Passenger Focus report to Cheshire
County Council on access requirements for
Chester Station

January 2007

**Passenger Focus
Chester Station**

Access Audit

Figure 1 – Car park signage.

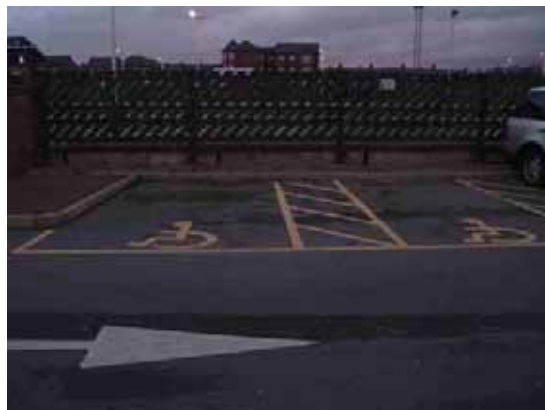
Ref	Room / Room Reference	Element	Existing Situation	Recommendations	Category	Fact Sheet Reference	Photo Ref
10	East Car Park	Signage	The signage located next to the pay and display machines confirms that blue-badge holders do have to pay to park in this area. However, this information is located on a sign over 2m high and this is likely to be more difficult to read for partially sighted people and people of shorter stature.	Provide information at a more convenient height between 1,400-1,700mm above ground level.	C	23	
11	East Car Park	Approach	The steps that lead up from this car park and onto the platform do not have colour contrasting nosings to assist partially sighted people identify individual steps.	Highlight step nosings using colour and tonal contrast.	A	11,25	3
12	East Car Park	Approach	These steps are provided with handrails on both sides which is good practice as it is likely to make the steps easier to negotiate for blind and partially sighted people and people with a reduced level of mobility. However, the handrails do not extend horizontally beyond the bottom step to provide guidance and support at this point.	Extend handrails at the bottom of this flight.	A	13	3

Figure 15 – Meeting room door.

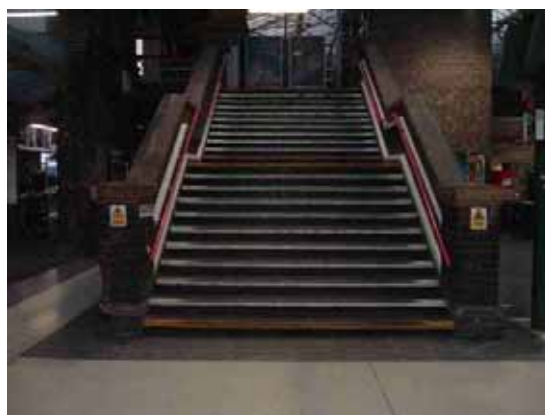
Ref	Room / Room Reference	Element	Existing Situation	Recommendations	Category	Fact Sheet Reference	Photo Ref
80	Meeting Room	Specific Areas	The door to the room provides only 650mm clear opening width which is unlikely to be sufficient for wheelchair users, people using mobility aids and people with assistance dogs. There appears to be scope to widen this door considerably.	Widen the door to provide at least 800mm, preferably 900mm clear opening width.	C	5	15
81	Meeting Room	Specific Areas	None of the seating in this room has armrests and this is likely to make the seating more difficult to use for people with a reduced level of mobility and blind and partially sighted people who require the support and guidance that armrests provide.	Provide a range of seating some with armrests and some without armrests.	C	15	
82	Meeting Room	Specific Areas	The seating does not contrast strongly with the floor surface and this is likely to make it more difficult to locate for partially sighted people.	Highlight seating using colour and tonal contrast.	C	25

Figure 16 – Main stairs.

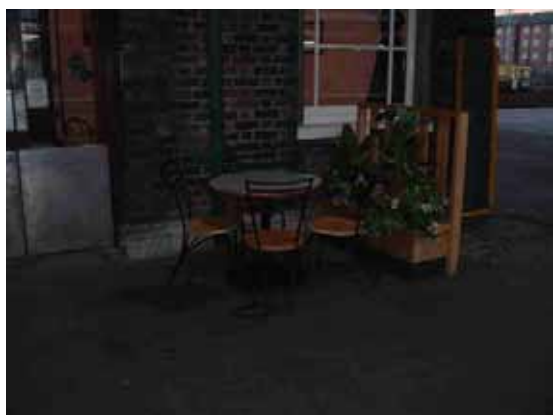
83	Meeting Room	Specific Areas	There is no hearing-enhancement system provided in this room to assist people who use hearing aids.	Install an induction loop.	C	27	
84	Meeting Room	Specific Areas	Lighting levels are good in this area and this is likely to make it easier for partially sighted people to move around the room and identify features within it.	N/A			
85	Stairs	Vertical Circulation	There is no tactile warning surface provided at the bottom of the steps to alert blind and partially sighted people to the presence of the steps.	Provide the tactile warning surface at the bottom of the two flights of steps.	A	4	16

Ref	Room / Room Reference	Element	Existing Situation	Recommendations	Category	Fact Sheet Reference	Photo Ref
86	Stairs	Vertical Circulation	The steps that provide access to platforms 4 to 7 from the main concourse area do have highlighted nosings which is a feature of good practice. However, the highlighting is extremely worn in places and this is likely to make the steps more difficult to use for partially sighted people.	Refresh the step nosings in order that a strong contrast is provided between the steps and the step nosings.	A	11,25	16
87	Stairs	Vertical Circulation	The steps are provided with handrails but the handrails do not extend horizontally at the bottom of the flight to provide support for people with a reduced level of mobility or guidance for blind and partially sighted people.	Extend the handrails at the bottom of this flight in accordance with best practice guidelines.	A	13	16

- Install the tactile warning surface at the bottom of both flights of stairs (i.e. on the two sides of the station).
- Provide handrails that extend 300mm beyond the top of the stairs.
